Access Compliance Report

Public Rights-of-Way

Intersection ID: 48134	Main Street: SQUIRREL_TRAIL_LN	Cross Street: ACORN_CREEK_LN	Location: NW
ADA ID: B3B32CAB3CA9	Ramp Type: PerpDiag	Initial Pass/Fail: Fail	Overall Compliance: No
Severity Score: 17.5			
Codes/Mitigation Info/Possible Solution		Field Measurements/Component Compliance

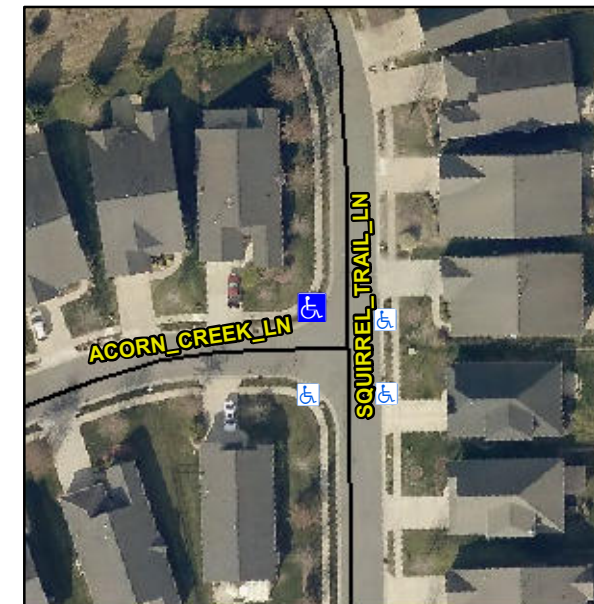
Not Found, R304.5.1

Compliance	Description	Data	Compliance	Description	Data
N/A	Ramp Length (in)	46.0	Yes	Ramp Slope (%)	5.1
No	Ramp Width (in)	35.0	Yes	Ramp XSlope (%)	1.2
N/A	Flare Type LT	N/A	N/A	Flare Type RT	N/A
N/A	Flare Slope LT (%)	N/A	N/A	Flare Slope RT (%)	N/A
N/A	Flare Traversable LT?	N/A	N/A	Flare Traversable RT?	N/A
N/A	Landing Length (in)	N/A	N/A	DWS Provided?	N/A
N/A	Landing Width (in)	N/A	N/A	DWS Contrast?	N/A
N/A	Landing Slope (%)	N/A	N/A	DWS Length (in)	N/A
N/A	Landing X Slope (%)	N/A	N/A	DWS Full Width?	N/A
N/A	Landing Curb? (Y/N)	N/A	N/A	DWS Offset (in)	N/A
N/A	Shared Landing?	N/A			
N/A	Gutter Ponding?	N/A	N/A	Gutter Slope (%)	N/A
N/A	Gutter Lip Ht (in)	N/A	N/A	Gutter X Slope (%)	N/A
N/A	Painted X Walk1?	No	N/A	Painted X Walk2?	No
	X Walk 1 Direction	To S		X Walk 2 Direction	To E
N/A	X Walk 1 Width (in)	N/A	N/A	X Walk 2 Width (in)	N/A
	X Walk 1 Slope (%)	0.2		X Walk 2 Slope (%)	1.6
	X Walk 1 X Slope (%)	1.1		X Walk 2 X Slope (%)	1.6

Remove & Replace Curb Ramp With Two New Directional Ramps or Equivalent.
